**Wichita-Sedgwick County Metropolitan Area Planning Department**

**Re: BZA2020-48: City Administrative Adjustment to reduce the north side yard setback of the Compatibility Standards for building and site design in "LC" Limited Commercial zoning adjacent to "SF-5" Single-Family Residential zoning.**

PROJECT: (ADDITION)  
O'REILLY AUTO PARTS STORE  
2219 S. SENECA  
WICHITA, KANSAS

## 1 BUILDING SETBACK VARIANCE EXHIBIT

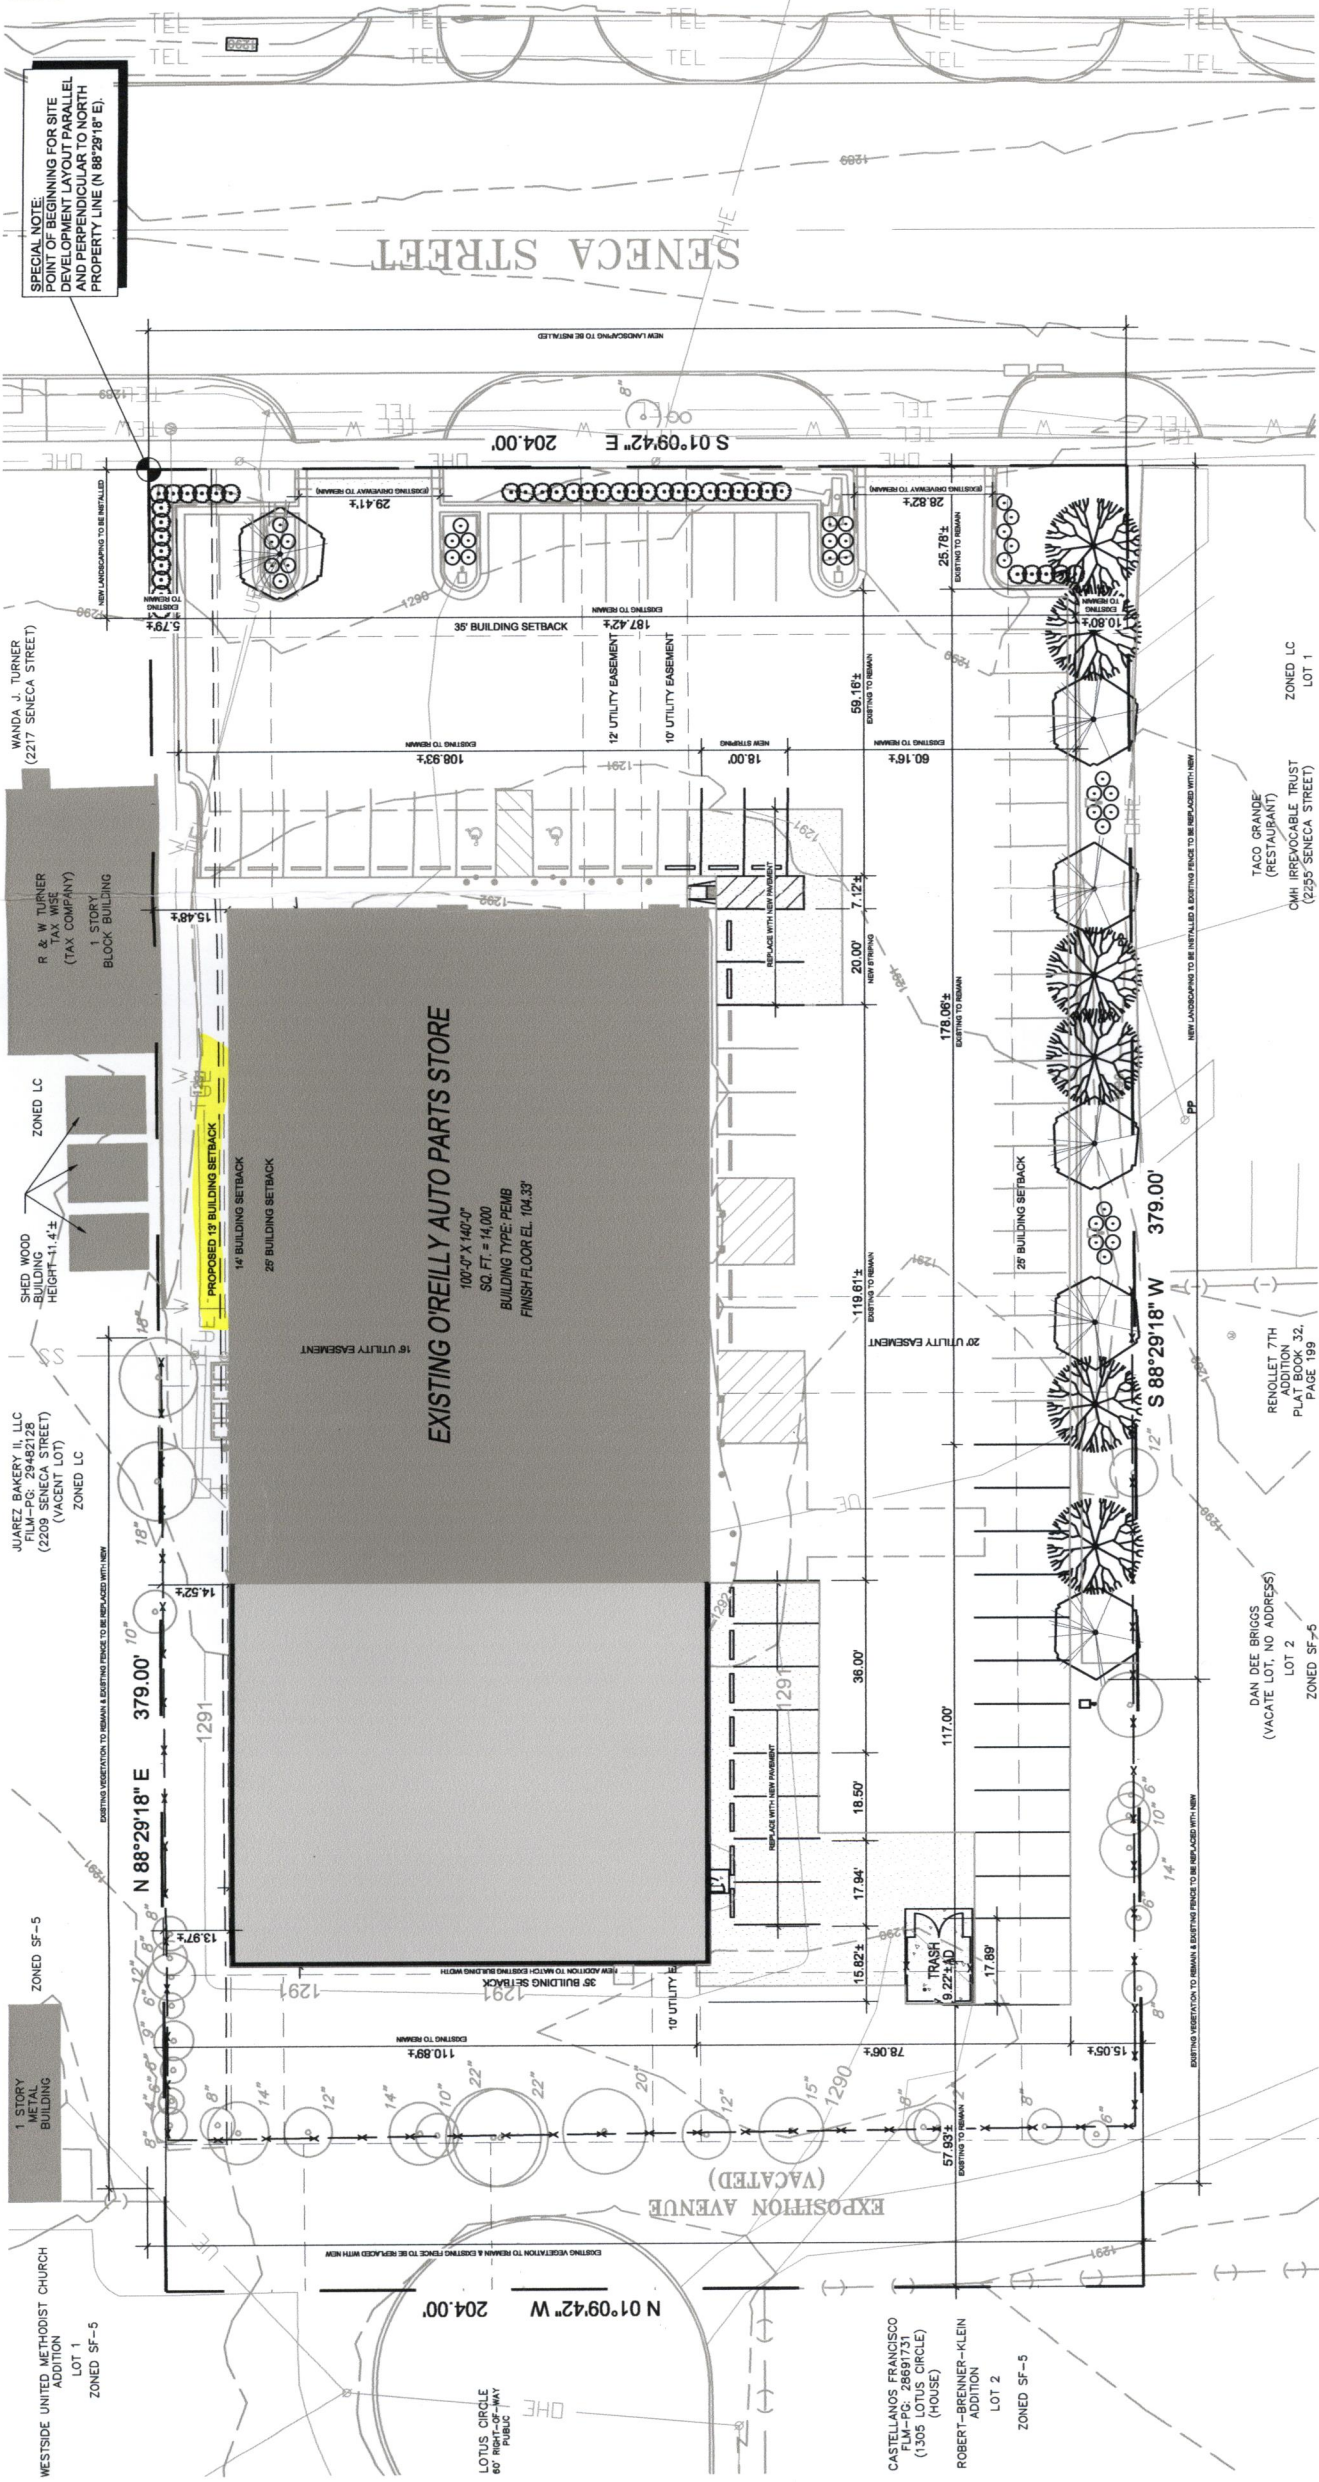
We reviewed your request for an Administrative Adjustment to reduce the Compatibility Standards on the north side yard setback [Sec IV-C.4] from 25 feet to 13 feet as shown on the submitted site plan. This Administrative Adjustment supersedes BZA2019-00023.

Section V-1.2.d of the Unified Zoning Code allows an Administrative Adjustment to reduce or waive the required compatibility setback. We find that reducing the north side yard compatibility setback as proposed, meets the four criteria required by Section V-1.6 as set out below:

- 1) Impact on safety and convenience of vehicular and pedestrian circulation: The reduction of the compatibility setback should have no impact on the safety and convenience of vehicular and pedestrian circulation in the vicinity as right-of-way and driveways are not affected.
- 2) Impact on existing uses in surrounding areas: There will be no impact on the existing uses

in surrounding areas as a result of the north side yard compatibility setback reduction; landscape buffering will be required per the City of Wichita Landscape Ordinance.

- 3) Compatibility with existing or permitted uses on abutting sites: The compatibility setback reduction with the landscape buffering separating the property on the north, will be compatible with existing and permitted uses on abutting SF-5 zoned site.
- 4) Effect on public health, safety or welfare: There will be no encroachment into public utility easements or right-of-way. There should be no impact on the public health, safety or welfare nor will properties or improvements in the vicinity be materially injured.

A VARIANCE IS REQUESTED TO ALLOW THE NORTH BUILDING  
SETBACK TO BE REDUCED FROM 14'-0" TO 13'-0" TO ALLOW  
FOR THE CONSTRUCTION OF A NEW BUILDING ADDITION TO THE  
REAR OF THE EXISTING O'REILLY AUTO PARTS STORE.

Our signatures below indicate that an Administrative Adjustment to reduce the north side yard building compatibility setback from 25-feet to 13 feet is hereby granted, subject to the following conditions:

- 1) This Administrative Adjustment supersedes BZA2019-00023.
- 2) The site shall be developed in general conformance with the approved site plan and the City of Wichita Landscape Ordinance.

- 3) The adjustment shall apply only to the north side yard compatibility setback as illustrated on the approved site plan. All other structures or additions on the subject property shall conform to the locations and setbacks permitted by the Unified Zoning Code unless a separate Zoning Adjustment or Variance is granted.

1 BUILDING SETBACK VARIANCE EXHIBIT

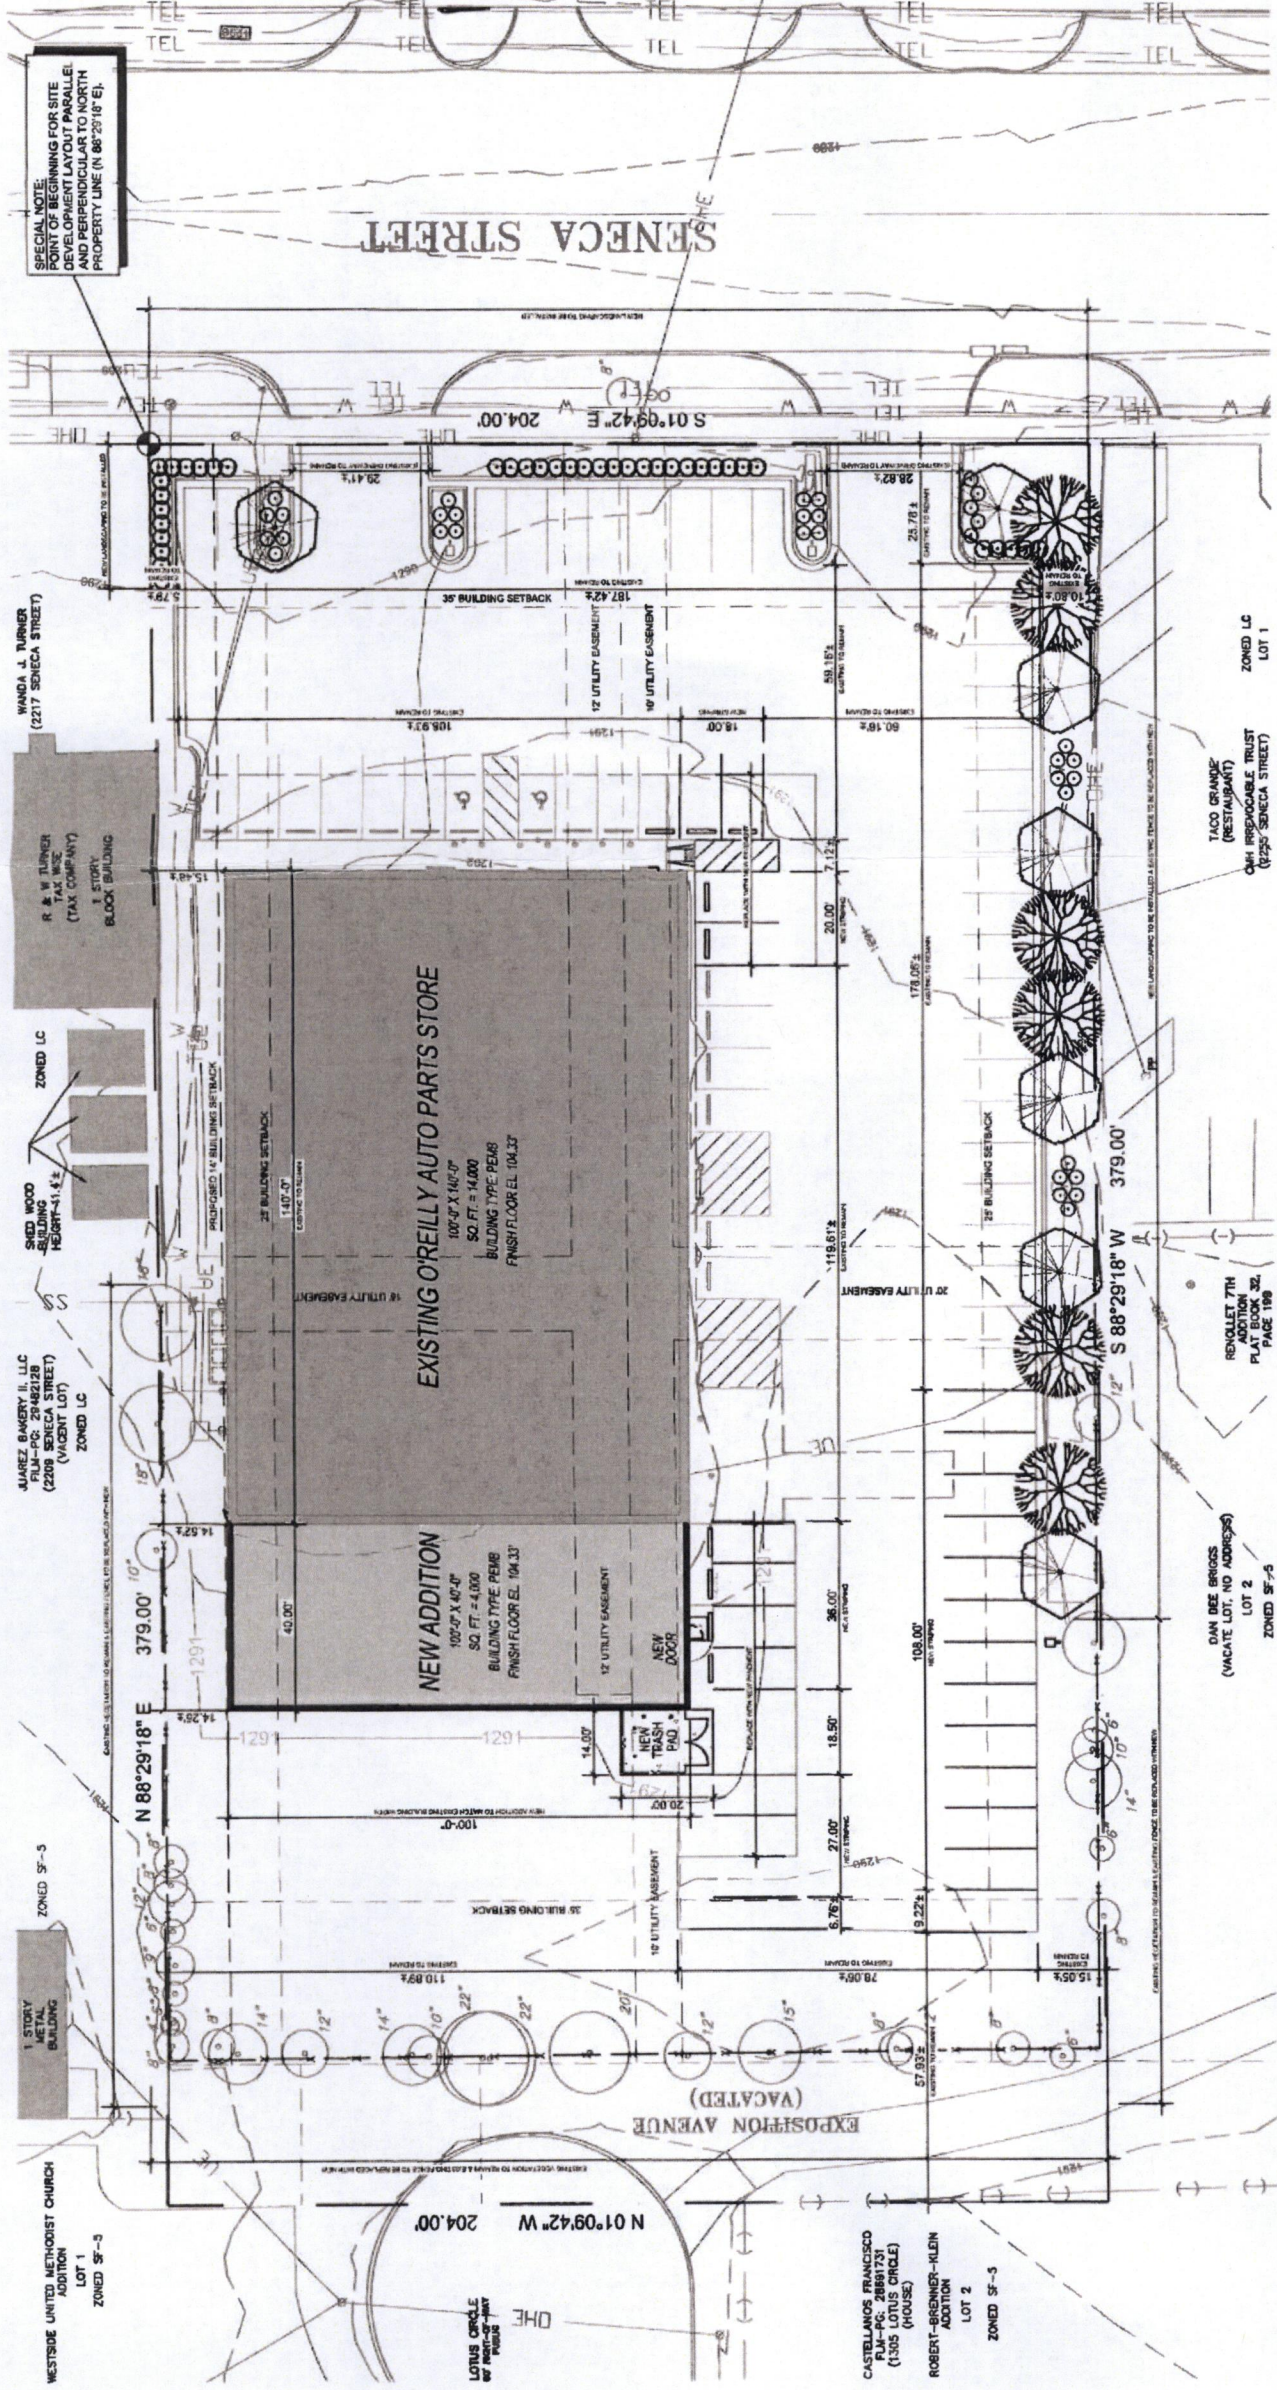
A VARIANCE IS REQUESTED TO ALLOW THE NORTH BUILDING SETBACK TO BE REDUCED FROM 25'-0" TO 14'-0" TO ALLOW FOR THE CONSTRUCTION OF A NEW BUILDING ADDITION TO THE REAR OF THE EXISTING O'REILLY AUTO PARTS STORE.
